PLANNING, ZONING, & BUILDING DEPARTMENT
PZ&B Staff Memorandum: Town Council Development Review

SUBJECT: ZON-22-122 (HSB-22-011) 141 AUSTRALIAN AVE (COMBO)

MEETING: JULY 12, 2023

Sheet 19, Existing South Elevation

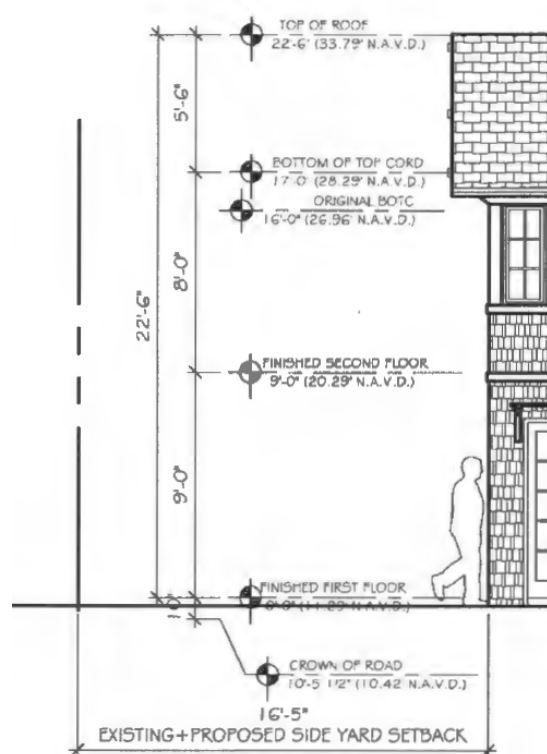
The parcel is located within the FEMA X zone, which is a Non-Special Flood Hazard Area of moderate to low risk. FEMA does not prescribe a finished floor elevation for this zone, but the parcel is relatively high by Palm Beach standards. Per the submitted plans, the building’s finished floor height will be increased with a new foundation from an elevation of 10.96’ NAVD to 11.50’ NAVD. In addition to the increased finished floor elevation, two (2) feet of additional height will be added to the structure’s ground floor walls, resulting in a floor-to-floor height of 10’-0”. The 2.54’ increase in height is most evident in the elevation drawings, provided on Sheets 19-20 of the architectural plan set.

Because the applicants are electing to increase the height of the building’s finished floor elevation and wall height for a reason other than FEMA compliance, the application will require the same

variances initially necessary to reconstruct the building, with modifications to variance amounts. Staff contends that the building could be rehabilitated with a new foundation without increasing the height of the building, and therefore eliminating the need for all five variances.
